MISSISSIPPI DEPARTMENT OF TRANSPORTATION

| SECTION 904 - NOTICE TO BIDDERS NO. **5411**

SUBJECT: **Safety Edge**

<p>NEW CONSTRUCTION</p>	 <p>OVERLAY 14' PAVEMENT</p>
 <p>OVERLAY 11' OR 12' PAVEMENT WITH TRENCH WIDENING</p>	 <p>OVERLAY 11' OR 12' PAVEMENT WITHOUT TRENCH WIDENING</p>
<p>SAFETY EDGE DETAILS 4/8/2011</p>

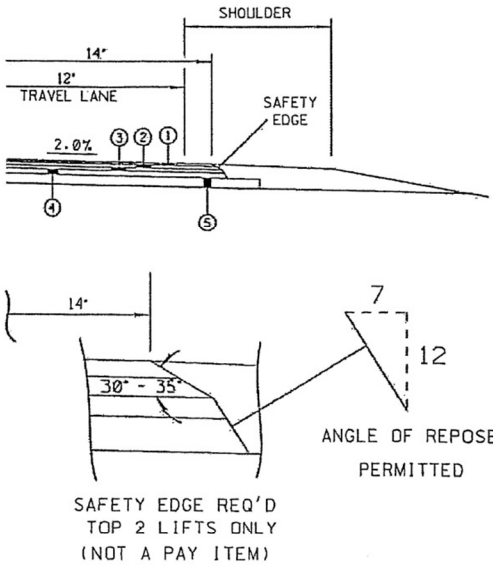
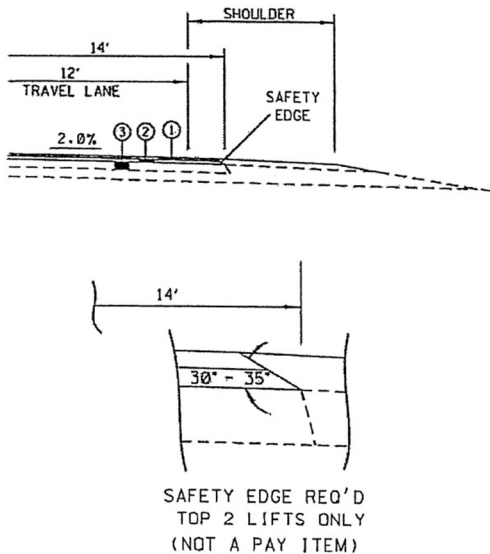
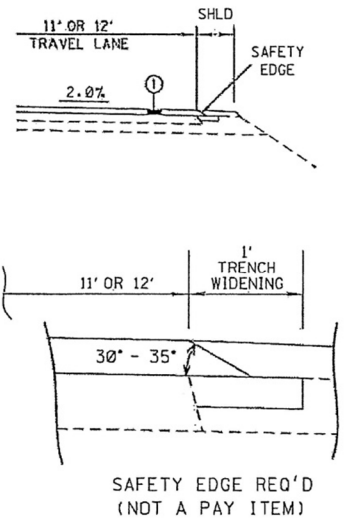
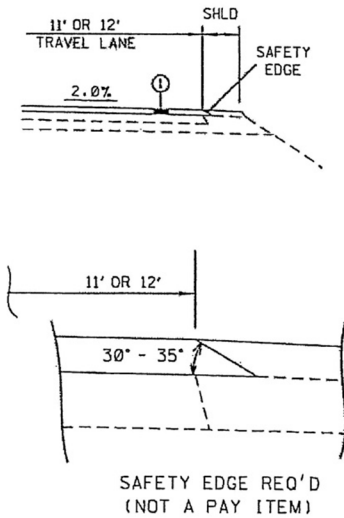
| Bidders are hereby advised that the Shoulder Wedge (Safety Edge) specified in Special Provision 907-401, [Asphalt Pavements](#), shall only apply to the top two (2) lifts of asphalt. [Open Graded Friction Courses \(OGFC\)](#) are not to be considered a lift as it pertains to safety edge. Attached is a drawing showing the safety edge.
